3. LAND

South of Embley Project

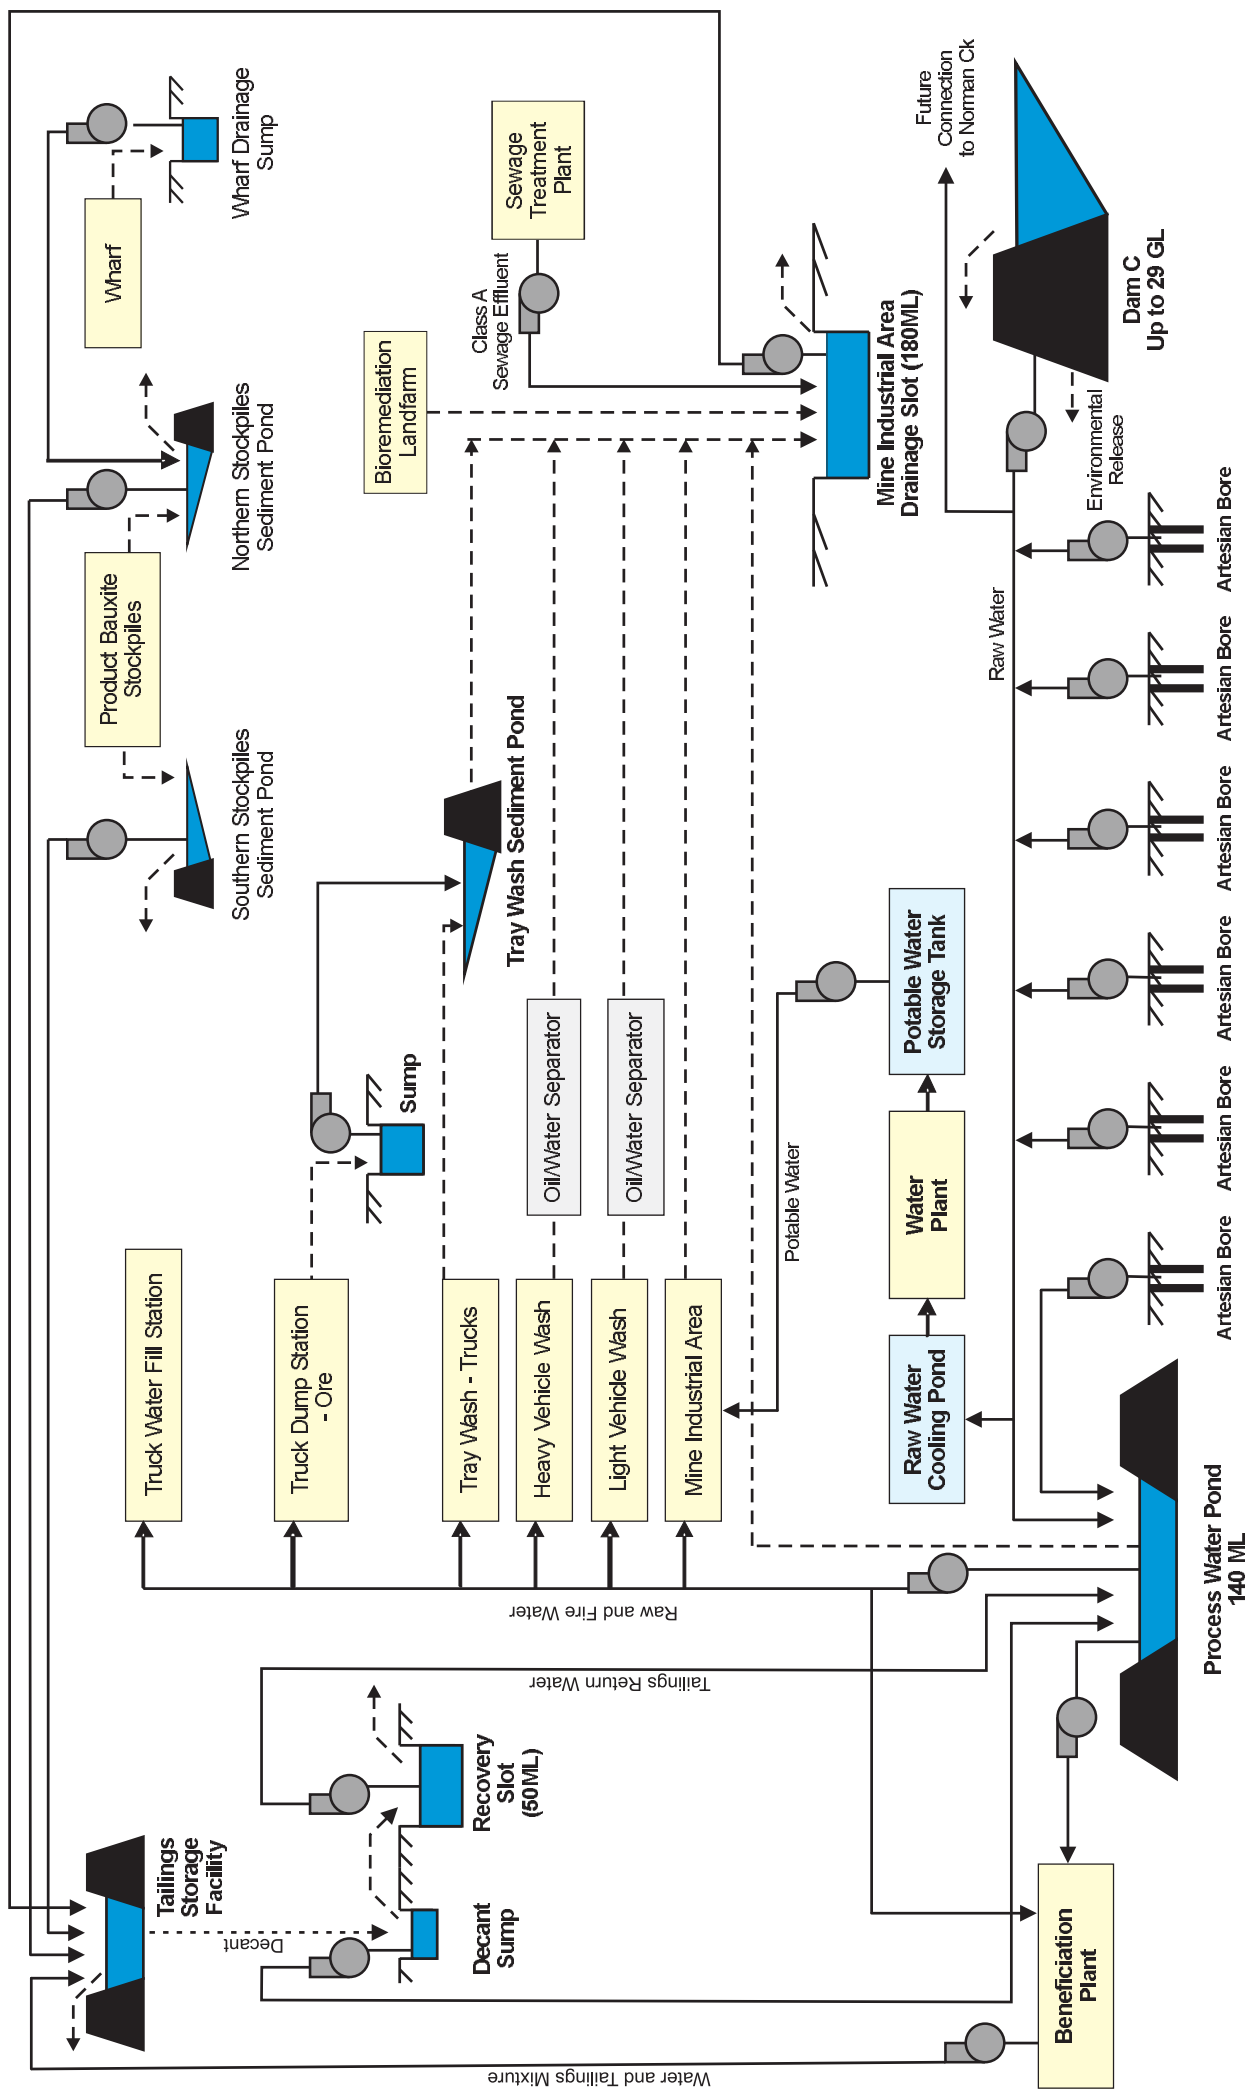
DERM raised a number of questions regarding the site water management system. **Figure 5-8(sup.)** and **Figure 5-9(sup.)** have been provided to address these concerns and reflect minor changes as a result of design refinements. Further information regarding stormwater management in the mine infrastructure area is also provided in the Environmental Management Plan (refer to **Appendix 3**).

**Fig. 5-11(sup.): Dam C
Spillway Design**

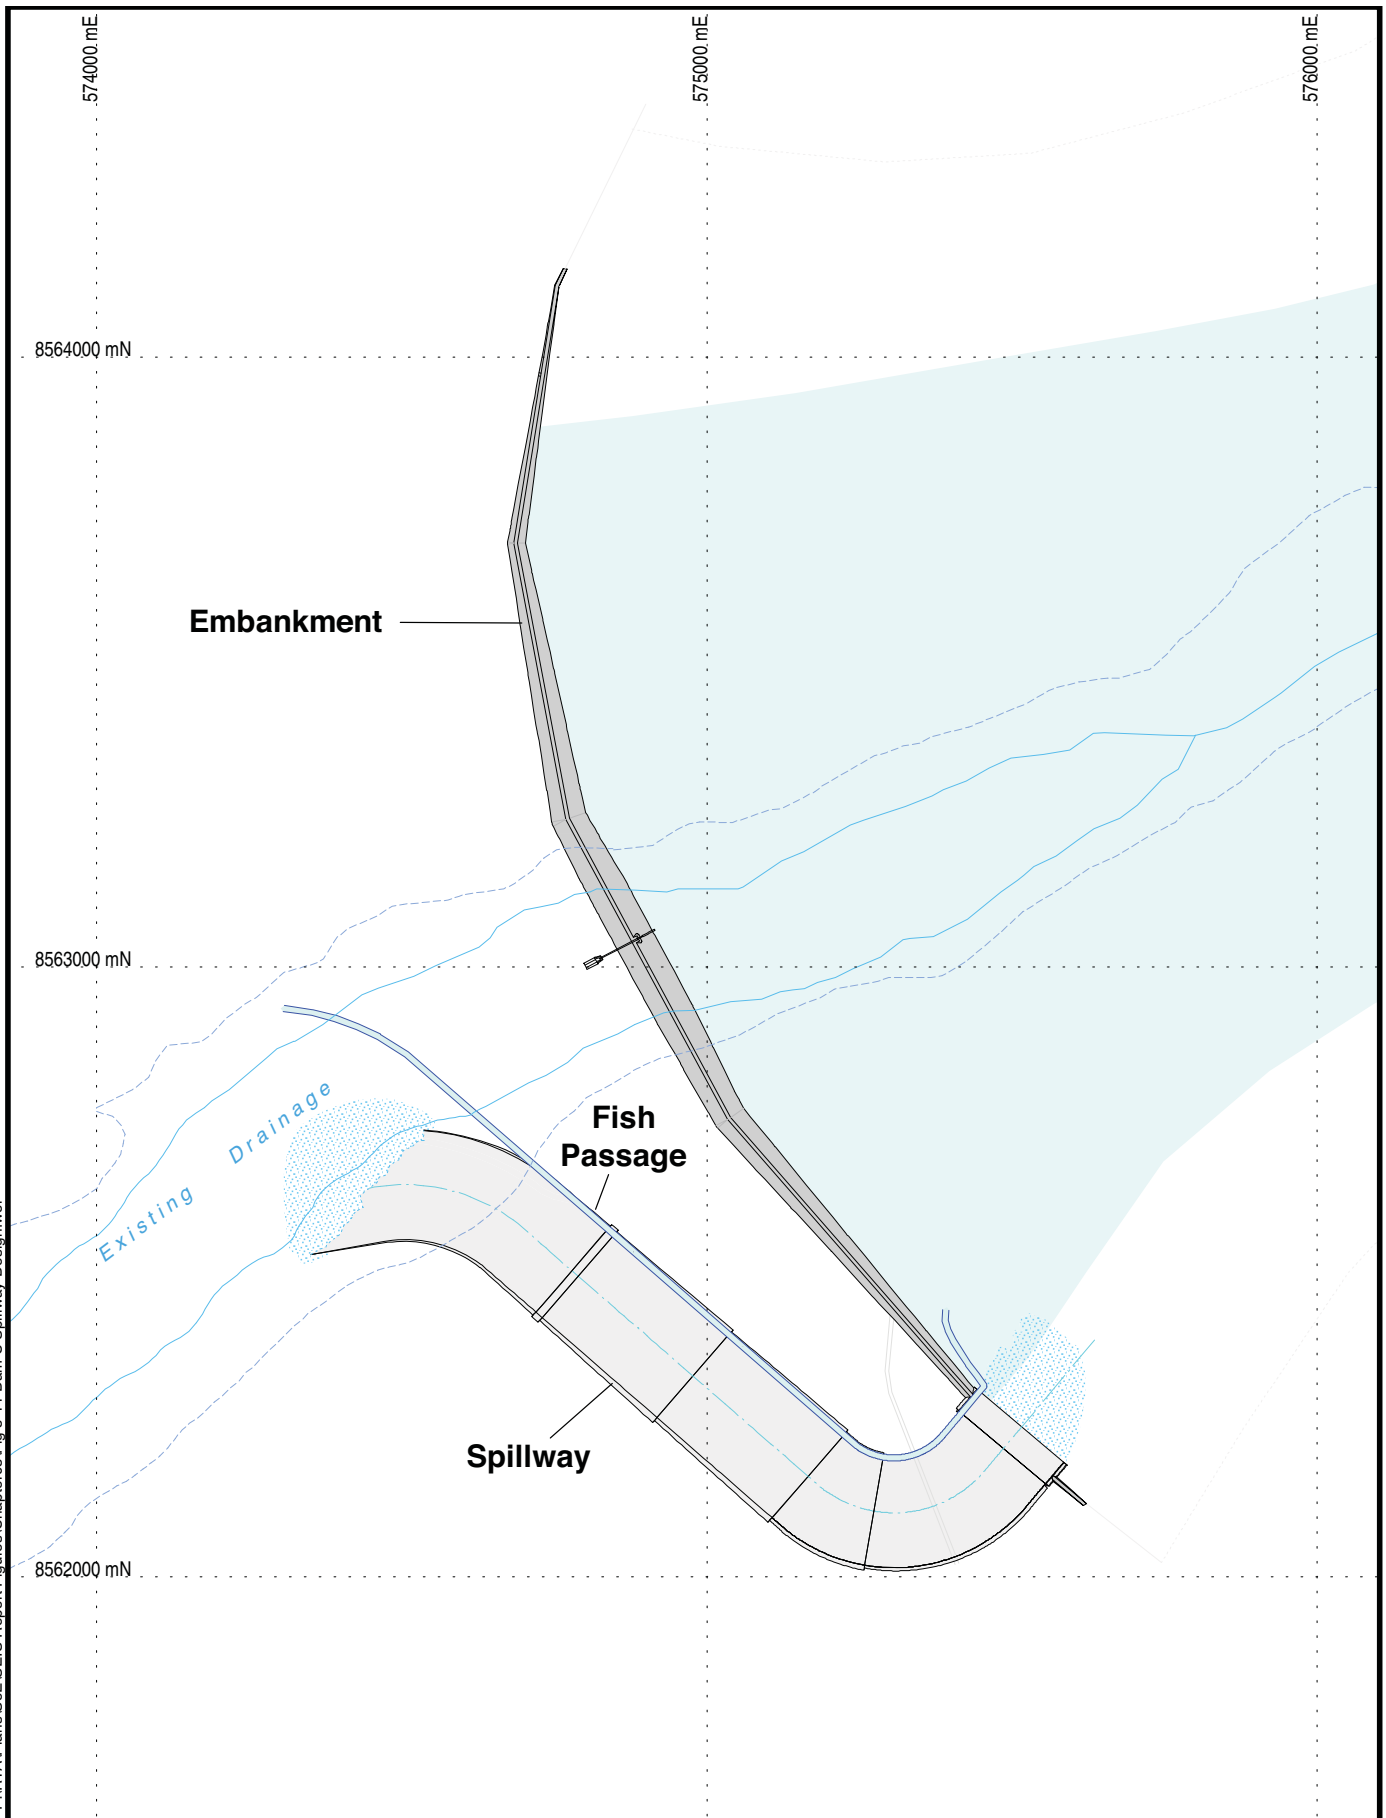
DEEDI FQ identified the main concern is that the current proposal for Dam C presented a barrier to fish passage at times when there will be downstream flow in Norman Creek. In a submission on the EIS, DEEDI FQ indicated the provision of fish passage during non-spill periods whenever there is an environmental release from the dam would be beneficial. The submission identified that this would necessitate a fishway that is operable over a range of headwater and tailwater conditions.

A change in fishway configuration is being assessed, which would integrate the fishway into the Dam C low gradient spillway channel in place of the spillway bypass channel fishway identified in the EIS. The configuration of this is shown in **Figure 5-11(sup.)**.

Based upon the assessment above it is the preferred option to modify the design of the current proposed fishway to address DEEDI's concern rather than provide a second mechanical fishway. The above options will however be further investigated and assessed in consultation with DEEDI FQ through the design process.

Fig. 6-57(sup.): Recreational Fishing Spots Near Port Area

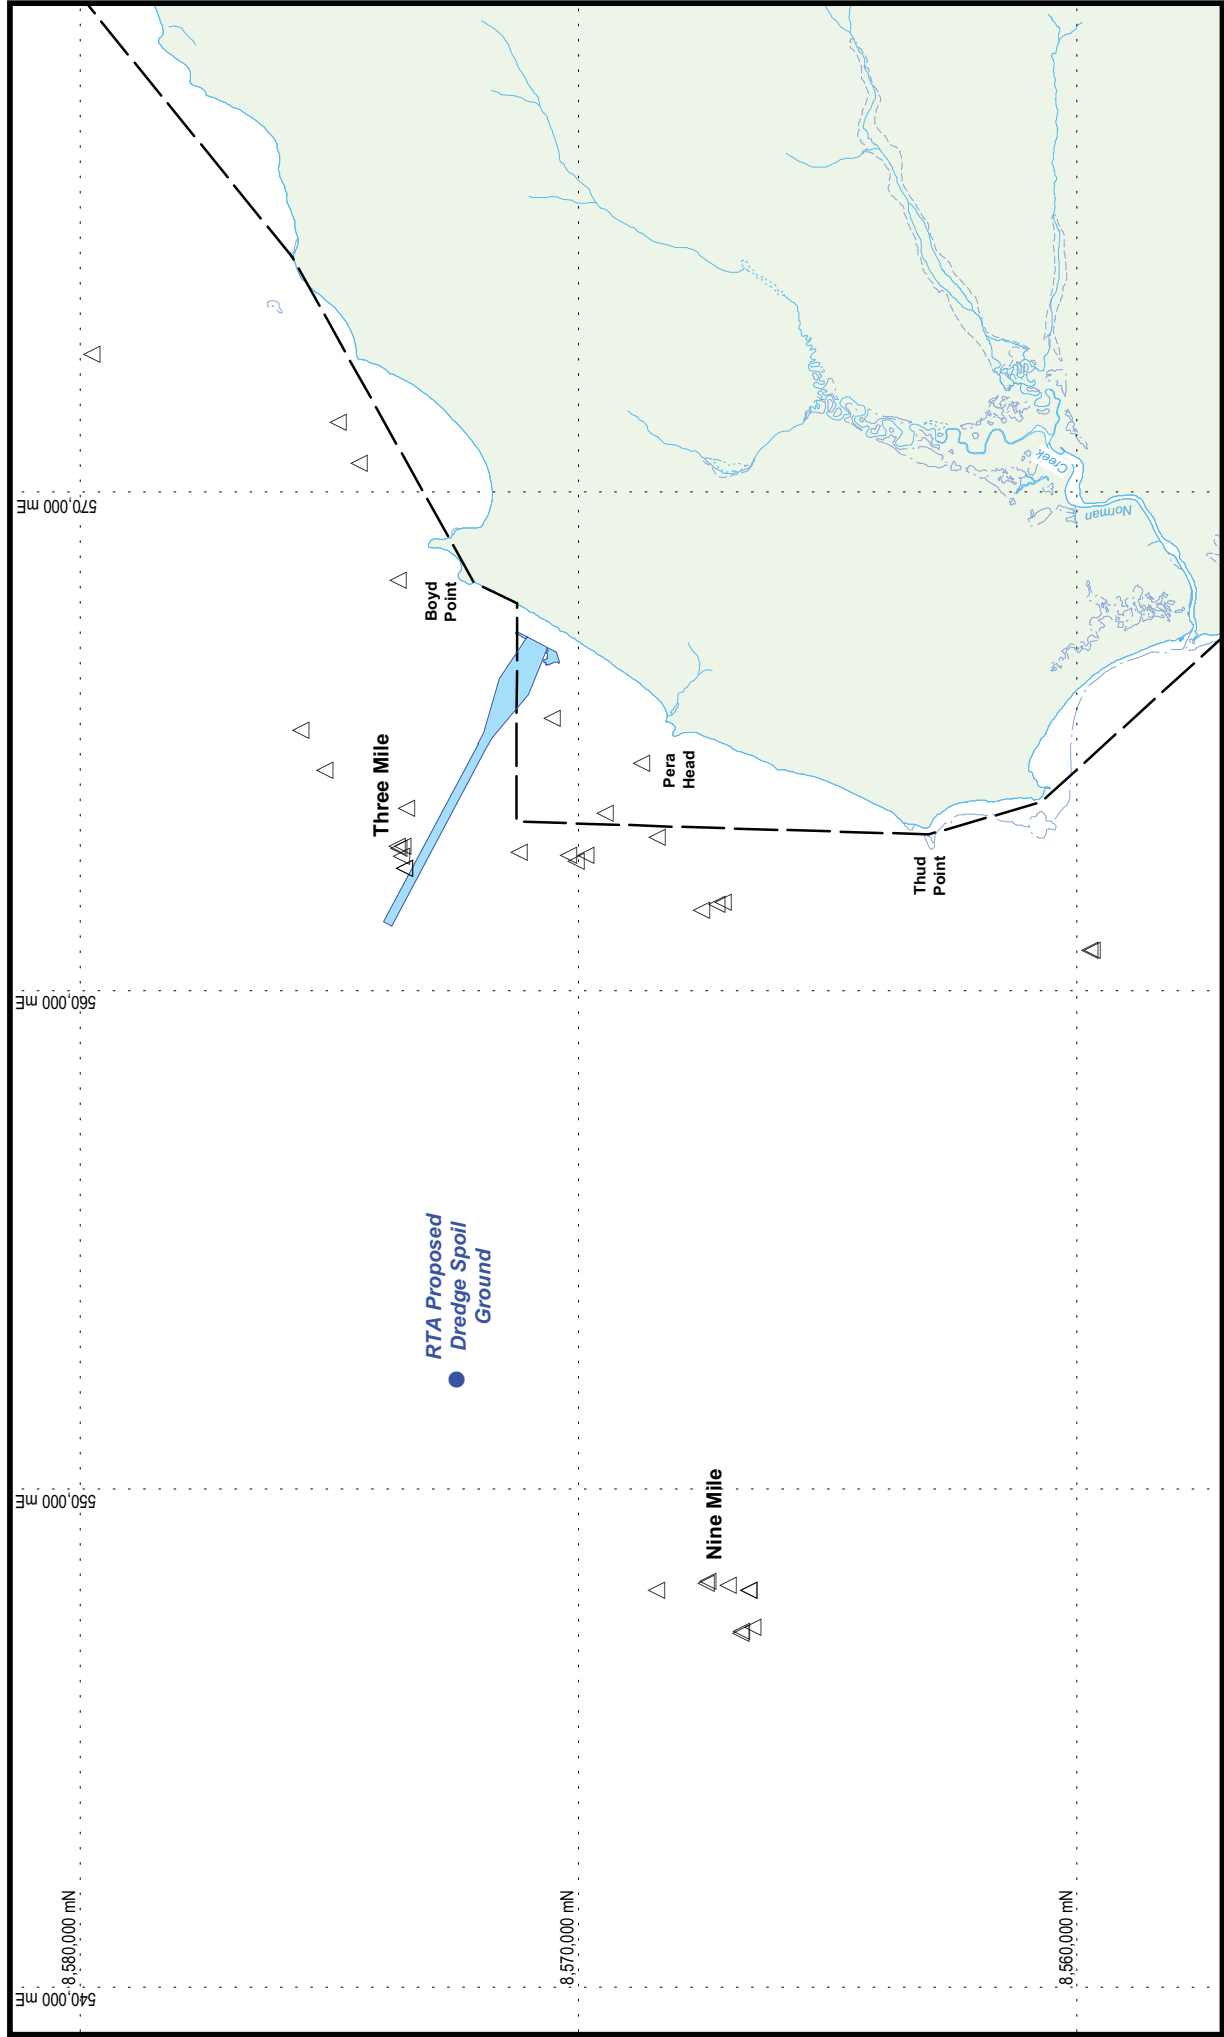
Figure 6-57(sup.) has been amended to show the "Three Mile" area. Targeted drop camera and towed sled surveys were carried out in the proposed dredge area where bathymetric survey indicated that there was potential for reefs to occur (refer Section 6.3.1.2 of the EIS). These surveys identified open benthic habitat in the berth and channel areas and included a survey point in the area identified as the "Three Mile" area. The EIS acknowledges that there would be a temporary impact on fish assemblages in the vicinity of the Port and spoil ground due to turbidity generated by dredging and disposal of sediment, however following dredging activities, the impacts are anticipated to be minor (Section 6.9.4.5 of the EIS). Since public exhibition of the EIS, a small two (2) degree alignment change to the south has been adopted (refer **Figure 2-6(sup.)** and **Section 2.6** of this Supplementary report. This realignment has the effect of reducing, but not eliminating, disturbance to the "Three Mile" fishing area

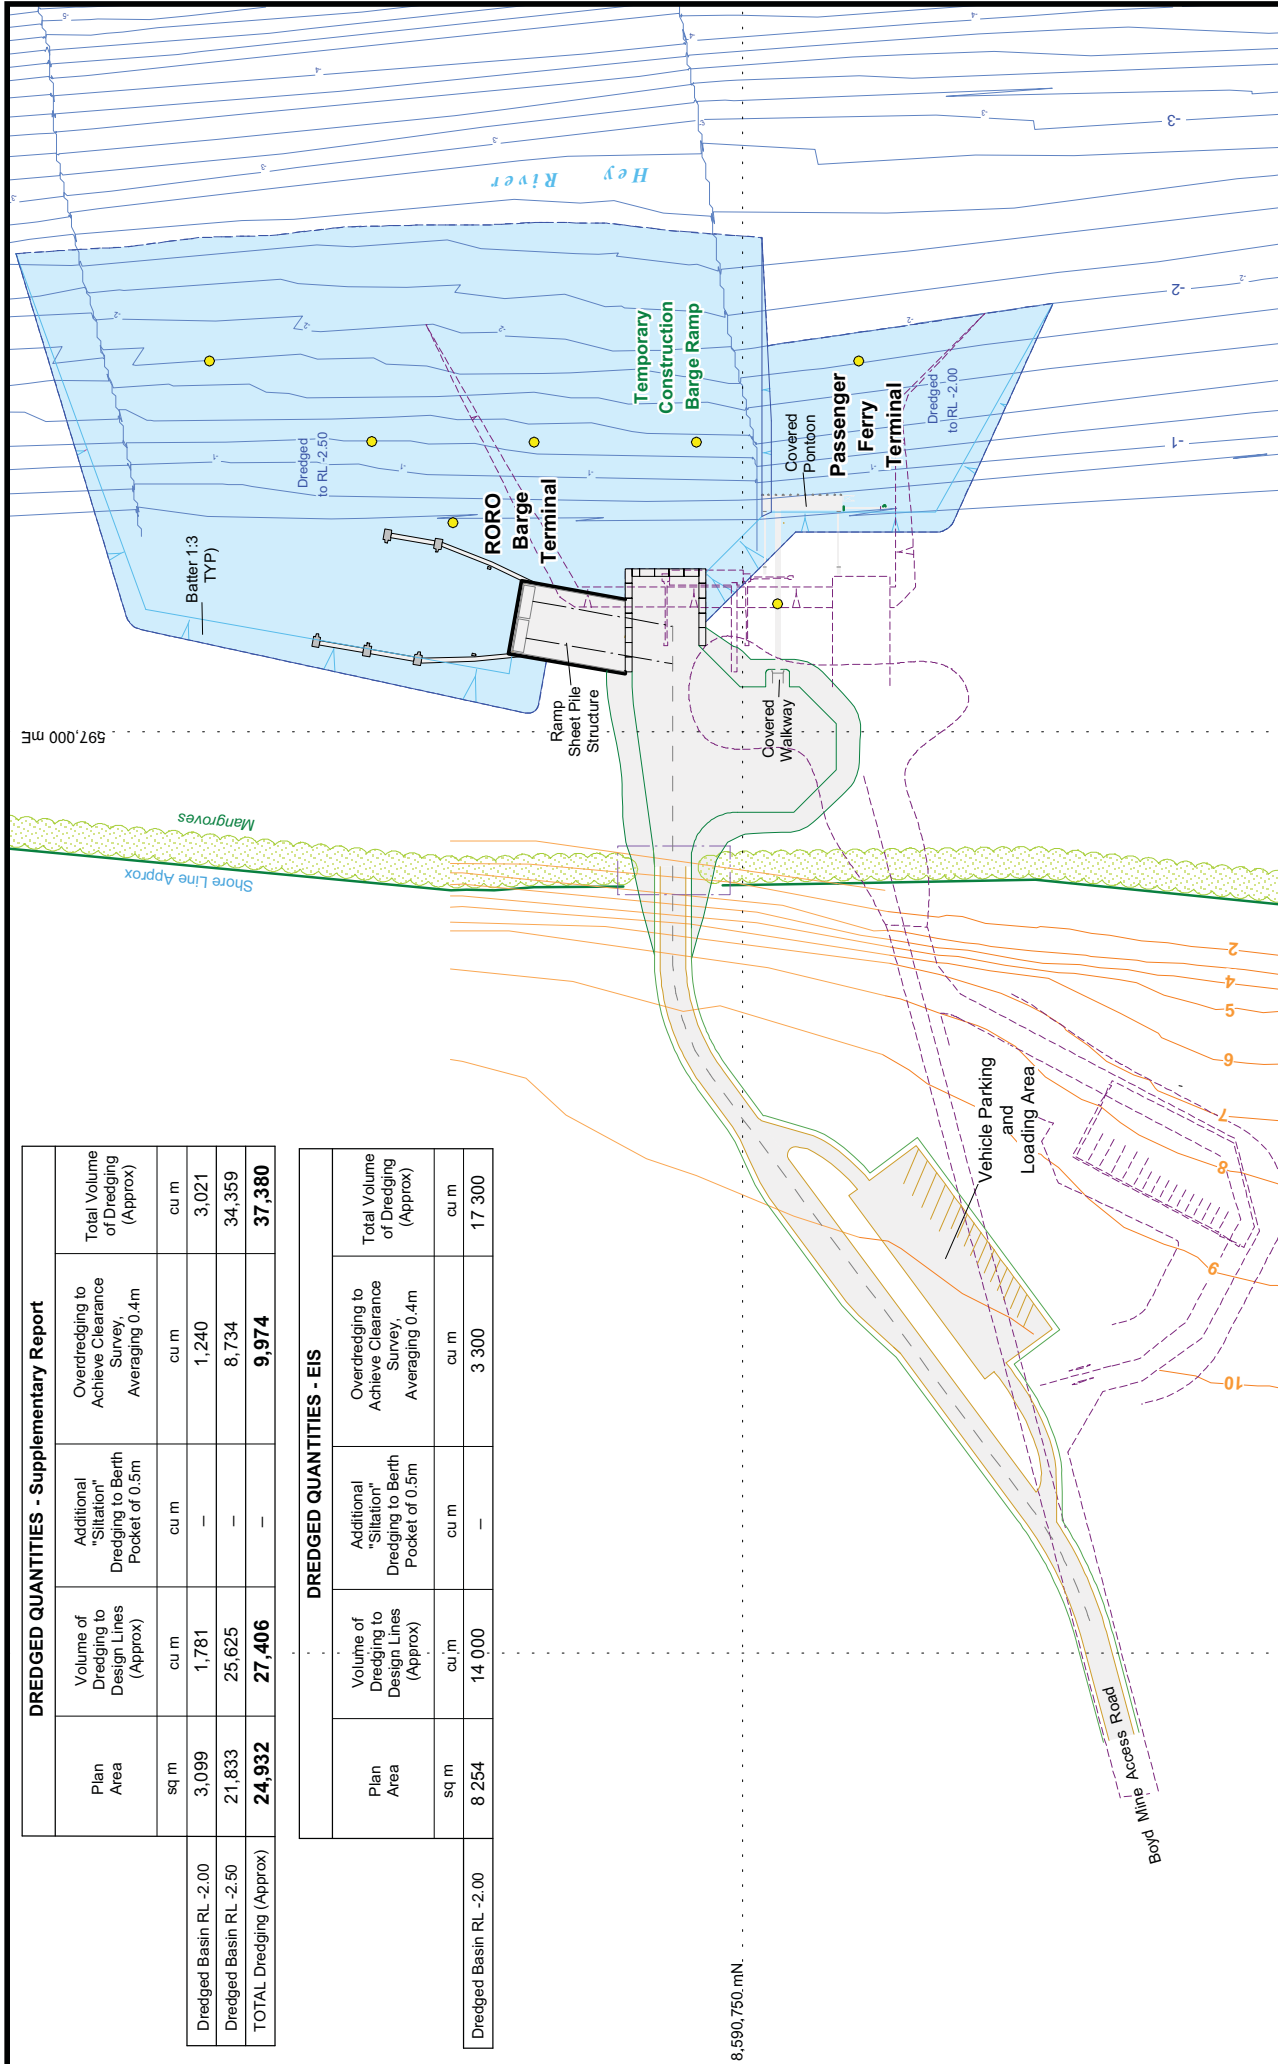
The layout of the Hey River terminal has been revised so that the barge berth is parallel to the bank, providing safer access. This design is similar to that originally proposed in the Sampling and Analysis Plan (SAP) which was approved by DSEWPac on 16 June 2009.

The proposed change results in an increase in both area and total volume over that presented in the EIS, but similar to that presented in the approved SAP. Table 6 of the NAGD would normally require nine sampling locations for this total volume. However, when the volume of potentially contaminated material is considered, Table 6 would only require eight sampling locations.

As described in the EIS, sediment samples were collected at seven locations across the area proposed in the approved SAP of 2009, which is similar to the current proposed footprint (refer **Figure J**). All contaminant means and 95% UCLs were below relevant NAGD screening levels, except for arsenic. Results of elutriate analysis identified that arsenic required only minimal dilution to achieve concentrations less than the 'low reliability' ANZECC/ARMCANZ (2000) water quality guideline values. Dilute Acid Extraction results were well below screening levels and indicated that arsenic is highly bound to sediments and therefore likely of geological origin. Power analysis against the screening level detailed in the sediment characterisation report indicates that only two samples were required for 17,300m³. The report concludes that the sediments are suitable for disposal at sea.
